NUREG-0692

final environmental statement

STEAM GENERATOR REPAIR

**SURRY POWER STATION, UNIT NO. 1
VIRGINIA ELECTRIC AND POWER COMPANY**

FIGURE 2
 TYPICAL RADIATION LEVELS AROUND STEAM GENERATORS
 WITH PRIMARY SIDE DRAINED AND SECONDARY SIDE AT
 72% LEVEL

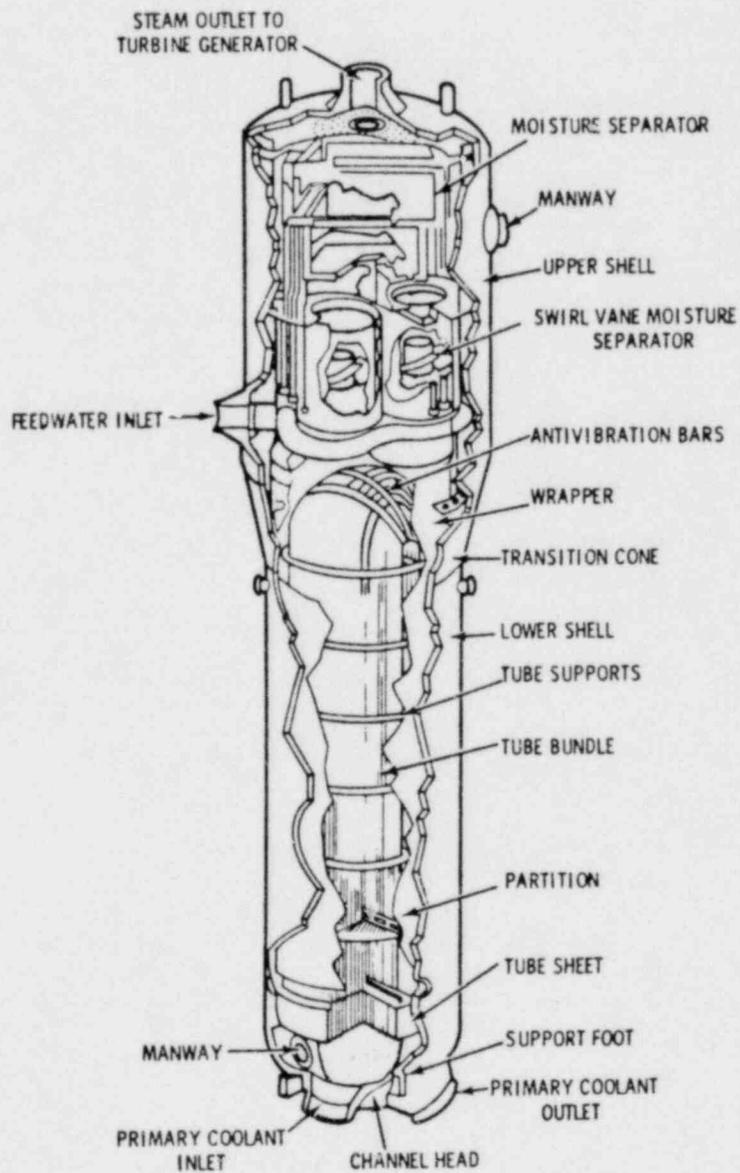
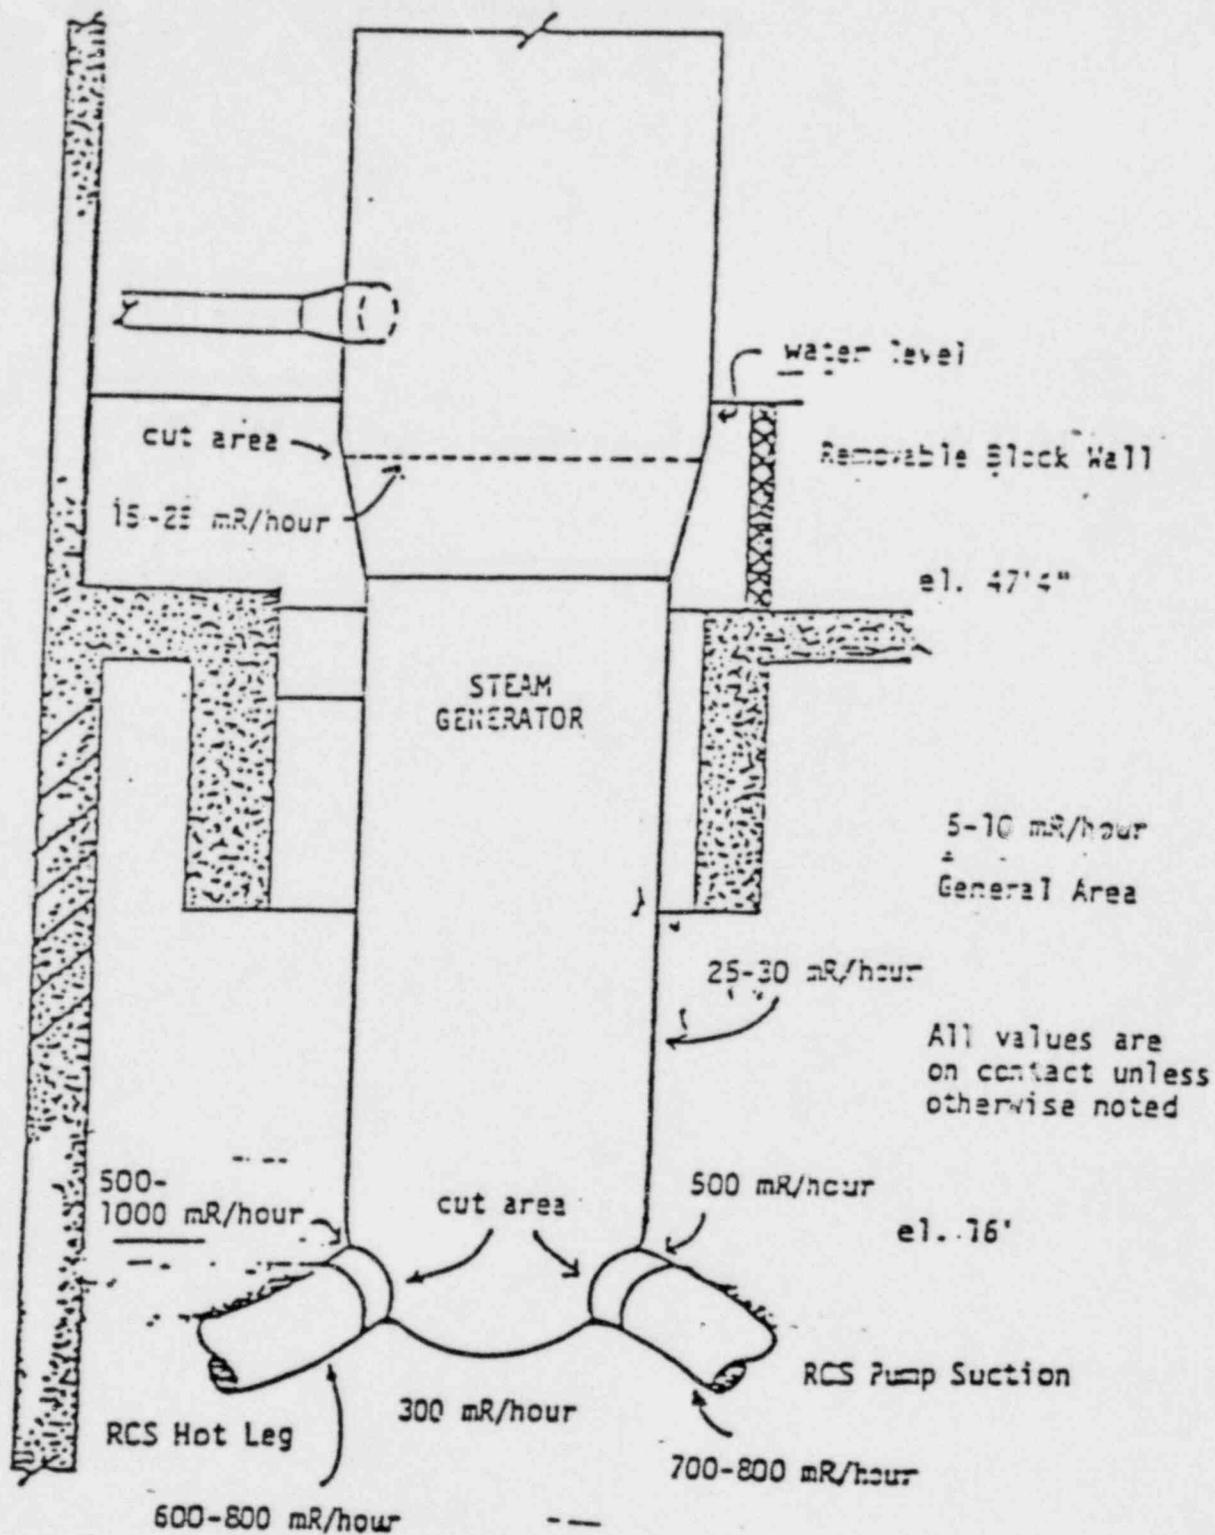
The diagrams provided at pp. 3-2 and 3-3 of the DES are impenetrable. Even the title of Figure 2 uses terms that are not explained, such as "Primary Side Drained and Secondary Side at 72% Level."

Site plan of Surry Power Station.

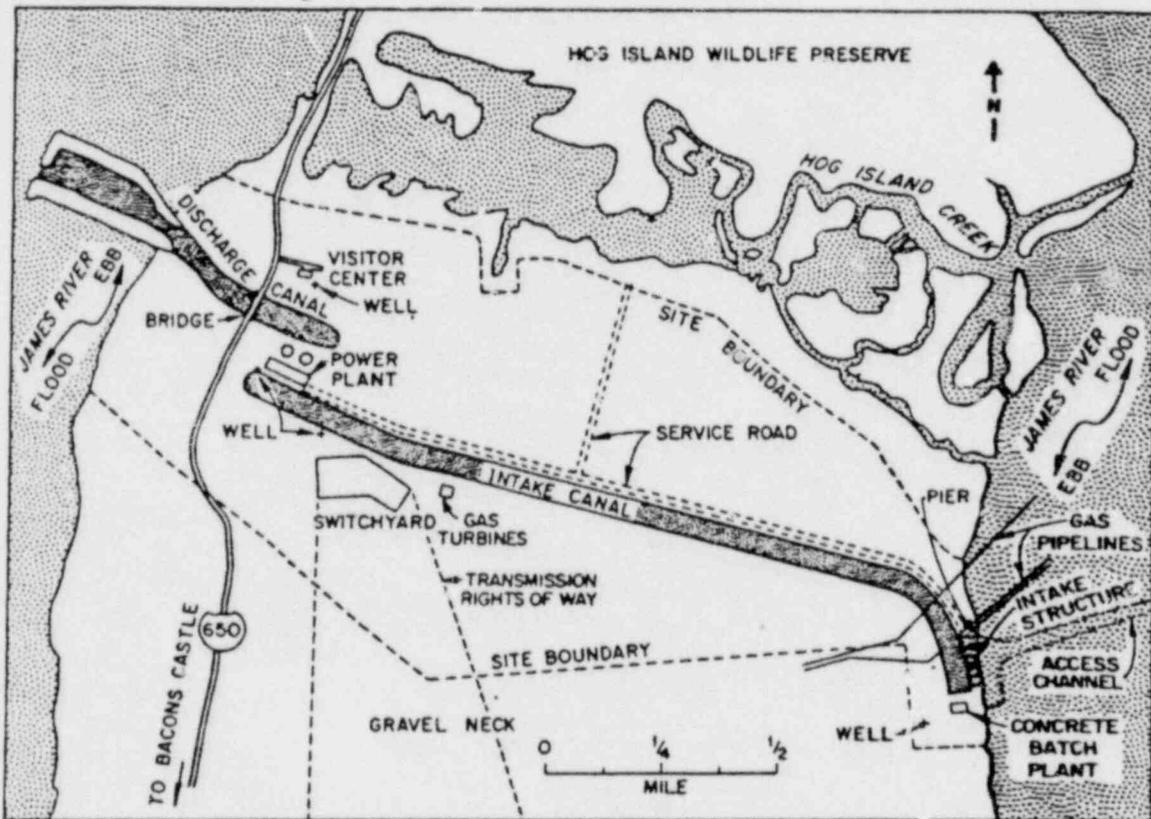
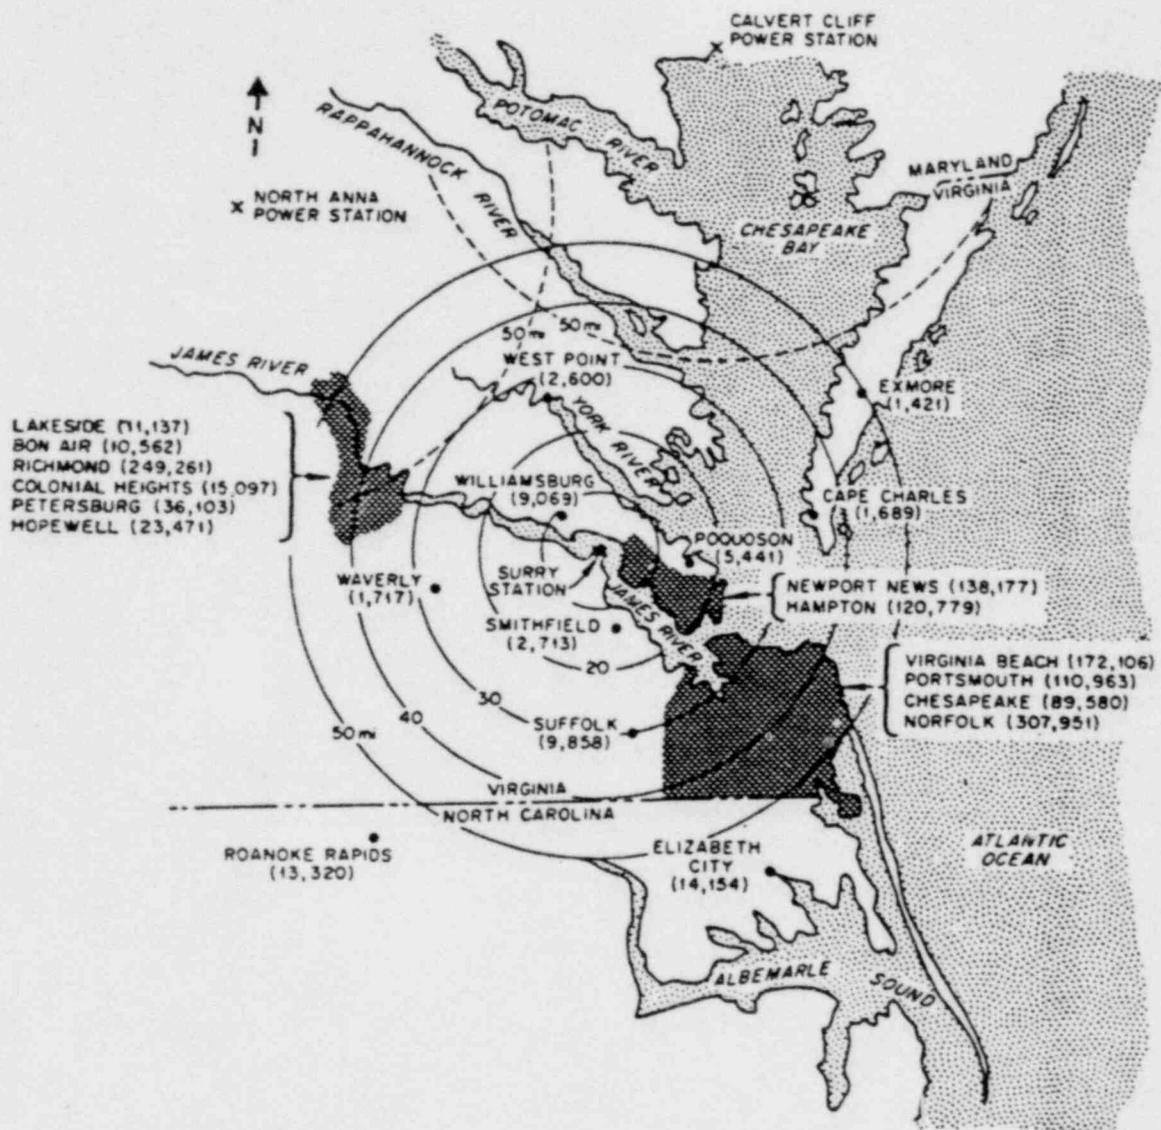
The draft is lacking a location map and site plan. We believe reviewers would find these of value in the final environmental impact statement. While the doses in the unrestricted areas are expected to be below normal operating levels during the repair, the final statement should describe a monitoring program to assure the public that the doses do indeed remain within acceptable levels.

The Final Environmental Statement for Surry Power Station, Unit 1, dated May 1972, provides a location map and site plan. These are also attached as part of this response.
